Submissions and Amendment Report

SSD 37558583 – Lot 1 Bringelly Road Business Hub Warehouse Facility
Response to Submissions

Figure 1 3d montage view from Bringelly Road

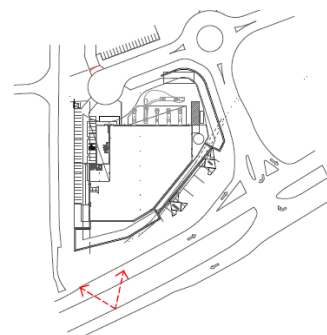
Comment	Response
It is acknowledged that significant retaining walls are proposed as part of the development. The engineering plans showing these may reach more than 3 m in height. The Department is concerned that retaining walls of this height may cause visual impacts. Further details are required to determine how these walls will impact on the visual amenity of the site, including the inclusion of these walls on elevation plans, multiple section plans and montages to demonstrate the visual impact of these retaining walls from within the subject site and from neighbouring sites.	The cut and fill strategy creates a lower pad compared to levels of Bringelly Road and Skyline Crescent. This reduces the scale of the warehouse perceived from these roads, thus minimising its impacts across the broader landscape. Therefore, the retaining walls will not be visually dominant in the surrounding areas. Refer to Appendix B for section plans/montages demonstrating the visual impact of the retaining walls. The Engineering Plans at Appendix E have been updated to reflect the amended design of the built form.

As a result, further assessment of built form has been carried out, in particular to respond to the DPE comment relating to urban design and elevations.

In response, the landscape design has been further developed to provide further screening of the proposed building from Bringelly Road (refer **Figure 1**).

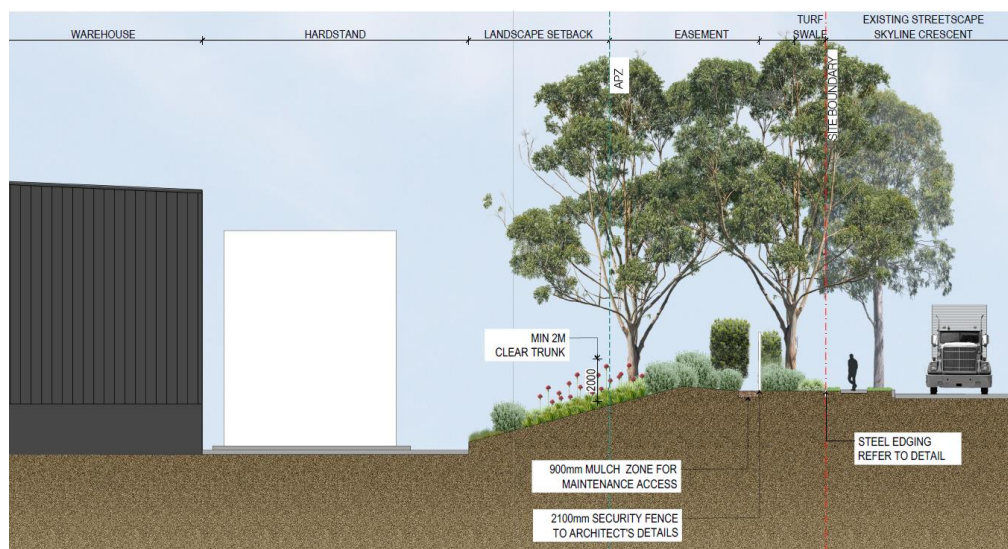
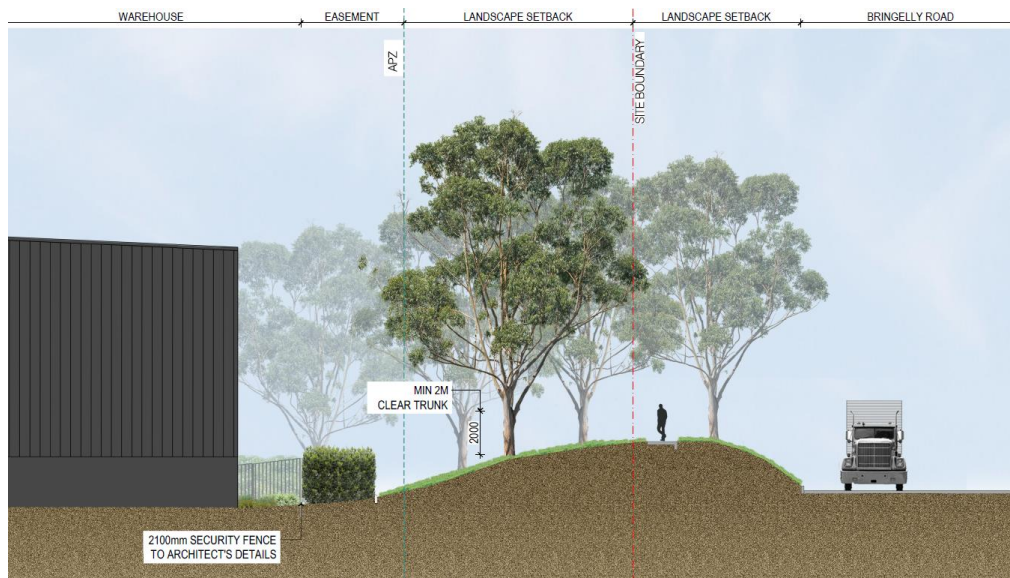
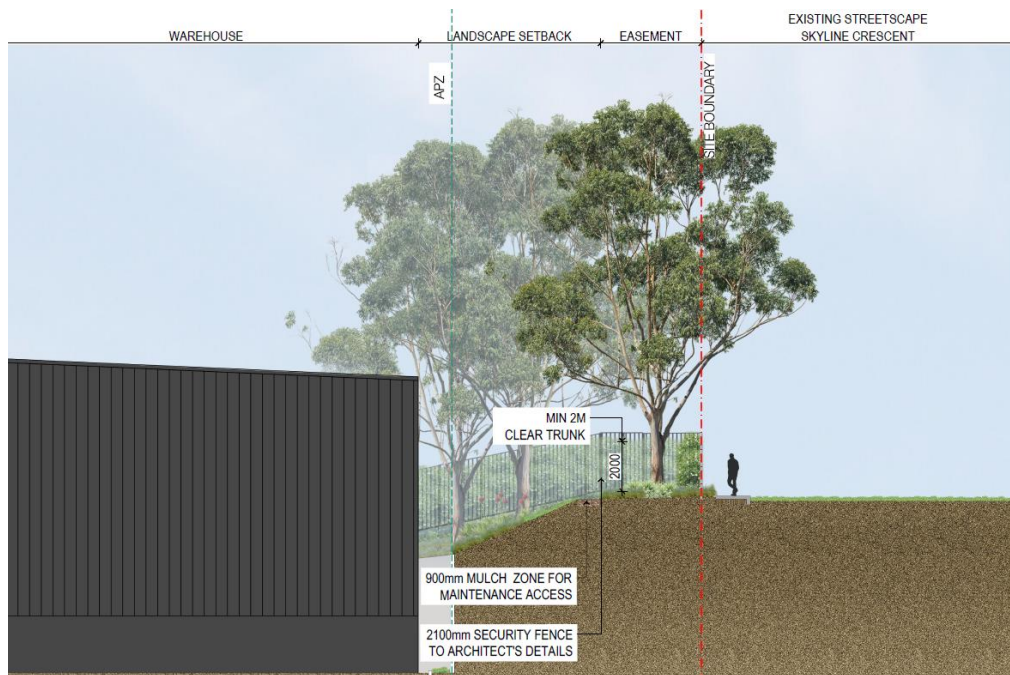
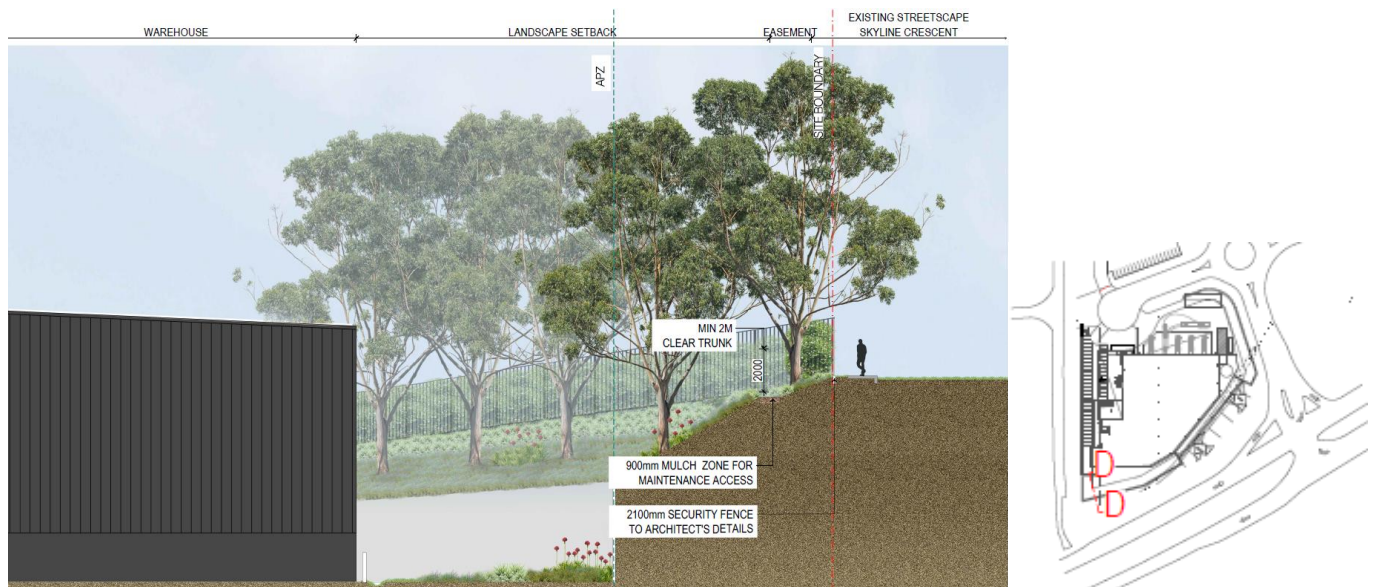
Consider additional offsets between the building and the retaining wall to provide access for maintenance and to safeguard the building. Provide detailed cross sections along Bringelly Road and Stuart Road (including the proposed building, retaining wall and landscaping) to illustrate the various interface treatments being proposed as part of the development.

Furthermore, a number of additional sections have been prepared to highlight the substantial level difference from the Bringelly Road corridor to the subject site, with tree planting indicated to ensure screening is provided, and also to create visual interest through creating a foreground of foliage, before the background of the built form elevations (which utilise multiple colours for visual interest) becomes apparent. This is shown further in **Figure 2** through **5**. Importantly, the built form will be nearly hidden by the proposed landscaping which is supported through the existing separation of levels of Bringelly Road and the site. This is particularly noticeable in **Figure 5** which highlights the clear visual separation from the two locations. This design response through landscaping to respond to the level changes and the use of colours on the built form façade, is considered to satisfy the requirements of Section 2.3 Control 8 of the Design Guidelines for the Bringelly Road Business Hub.
